# Access Compliance Report

## Public Rights-of-Way

### (Curb Ramps)

Intersection ID: 48195	Main Street: BLAKENEY CENTRE DR	Cross Street: REA RD	Location: NW
ADA ID: 9D43D4E4E5D3	Ramp Type: BlendTrans2	Initial Pass/Fail: Fail	Overall Compliance: No
		Severity Score: 10

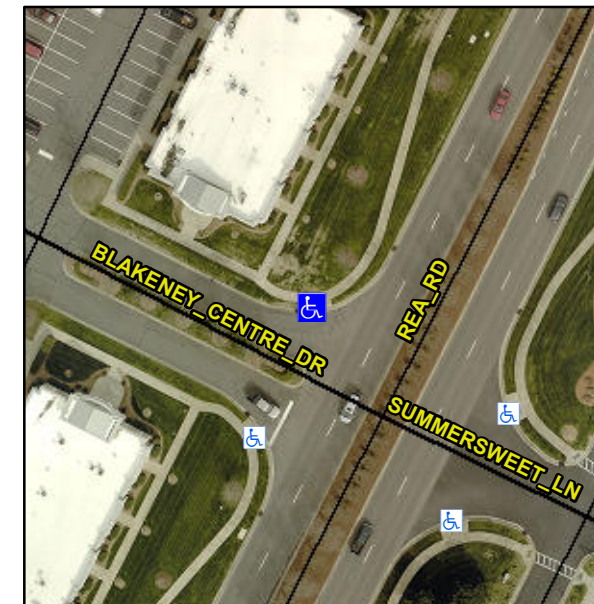
**Not Found, R304.5.1, R304.5.3**

Compliance	Description	Data	Compliance	Description	Data
N/A	Ramp Length (in)	96.0	Yes	BlendTrans Slope (%)	3.7
No	Ramp Width (in)	45.0	No	BlendTrans XSlope (%)	2.2
N/A	Flare Type LT	N/A	N/A	Flare Type RT	N/A
N/A	Flare Slope LT (%)	N/A	N/A	Flare Slope RT (%)	N/A
N/A	Flare Traversable LT?	N/A	N/A	Flare Traversable RT?	N/A
N/A	Landing Length (in)	N/A	N/A	DWS Provided?	N/A
N/A	Landing Width (in)	N/A	N/A	DWS Contrast?	N/A
N/A	Landing Slope (%)	N/A	N/A	DWS Length (in)	N/A
N/A	Landing X Slope (%)	N/A	N/A	DWS Full Width?	N/A
N/A	Landing Curb? (Y/N)	N/A	N/A	DWS Offset (in)	N/A
N/A	Shared Landing?	N/A			
N/A	Gutter Ponding?	N/A	N/A	Gutter Slope (%)	N/A
N/A	Gutter Lip Ht (in)	N/A	N/A	Gutter X Slope (%)	N/A
N/A	Painted X Walk1?	No	N/A	Painted X Walk2?	N/A
	X Walk 1 Direction	To SW		X Walk 2 Direction	N/A
	X Walk 1 Width (in)	N/A		X Walk 2 Width (in)	N/A
	X Walk 1 Slope (%)	0.5		X Walk 2 Slope (%)	N/A
	X Walk 1 X Slope (%)	2.5		X Walk 2 X Slope (%)	N/A

N/A	Ramp inside XWalk1?	N/A	N/A	Ramp inside XWalk2?	N/A
	Road Slope (%)	2.5		Clear Space?	N/A
	Road X Slope (%)	0.5	N/A	Clear Space to XWalk (in)	N/A
N/A	Any Obstructions?	N/A	N/A	Storm Grate/Utility Hazard?	N/A
	Obstruction Type			Storm Grate/Utility Type	
		N/A			N/A
			Yes	Surface Condition? (G/P)	Good
			No	Curb Slope (%)	10.4

**Remove & Replace Curb Ramp With Two New Directional Ramps or Equivalent.**
